Mine Safety Appliances Company • Instrument Division • P.O. Box 427 • Pittsburgh, PA 15230-0427

United States Nuclear Regulatory Commission
Sealed Source Safety Section
Division of Industrial and Medical Nuclear Safety
Attn: Ujagar S. Bhachu
Two White Flint North
11545 Rockville Pike
North Bethesda, MD
20852

ASSIGNMENT NUMBER: 99-02

April 26,2000

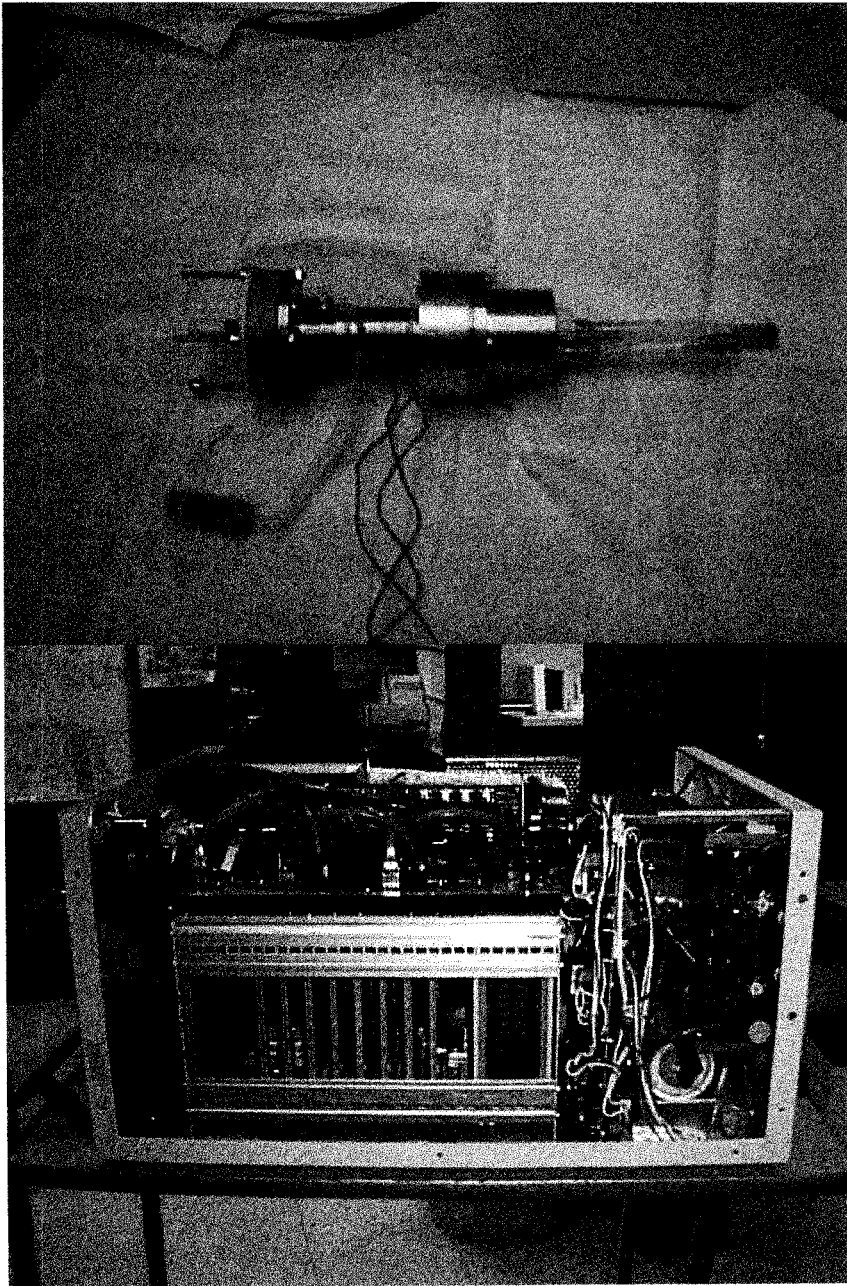
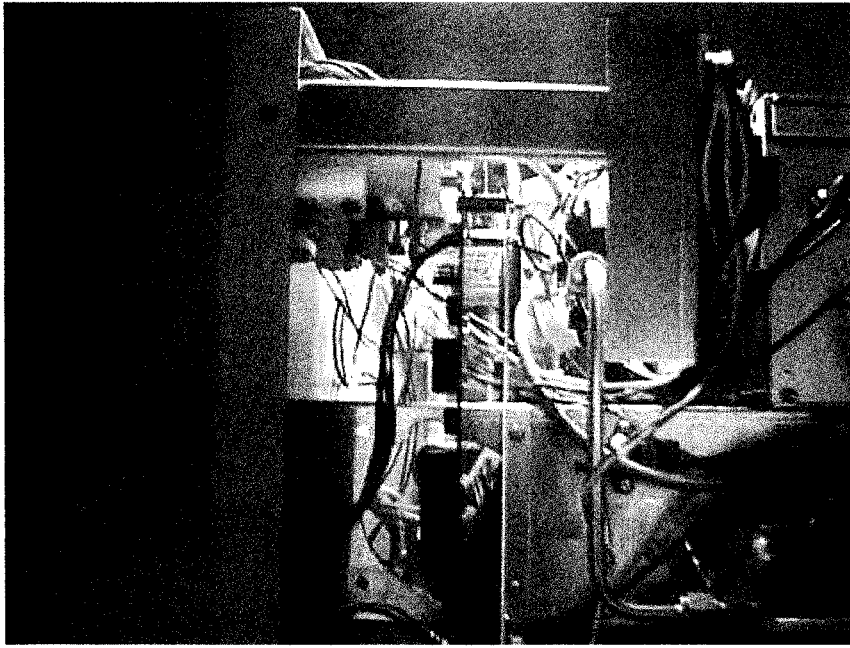
- 1.1 Please demonstrate that external screws used to assemble the device are temper proof.
- Using the Guidance provided in Draft NUREG/CR-6642 “ **Risk Analysis and Evaluation of Regulatory Options for Nuclear Byproduct Material Systems**”.

- Section 3.27.5 step 6 states that “ **shielding is not an issue for these sources and access control is not worthwhile except for prevention of loss of the source.**”

- Section 3.27.5 Step 4. “**The key function is confinement.**” MSA is using custom screws to hold the source housing together. “**The user is charged with not compromising the safety case of the instrument.**”

- See attached photos of the mounted source housing inside the instrument case. It would take a deliberate act to remove the source housing, dismantle this housing and then a significant force would be needed to remove the pressed in source.

- As a permanent instrument, the risk for theft is minimal.
